STUDY on LED replacement light sources introduction into Regulation No. 37

The attached document is a study on how LED replacement light sources can be introduced into Regulation No. 37.

**STUDY on LED
replacement light sources
introduction into R37
Status 2020-07-08**

Addendum 36 – Regulation No. 37

Examples of the arrangement of the approval mark and specific identification code

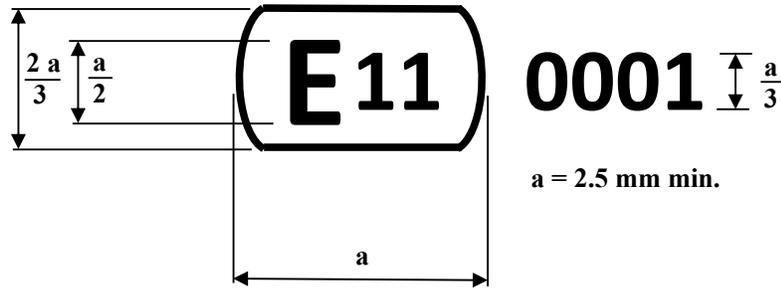
- 2.3.6.3. the specific identification code, or if it concerns a new application, a space sufficient to accommodate the specific identification code.
- 2.3.7. The specific identification code of an AE device shall comprise the starting character “Æ” for “ADDITIONAL ELECTRONICS”, followed by the distinguishing number of the country of the approval authority and, separated by a single character space, the approval code of the LED replacement light source, with which the additional electronics device(s) has/have been approved. Annex 3 to this Regulation gives an example of arrangement of a specific identification code
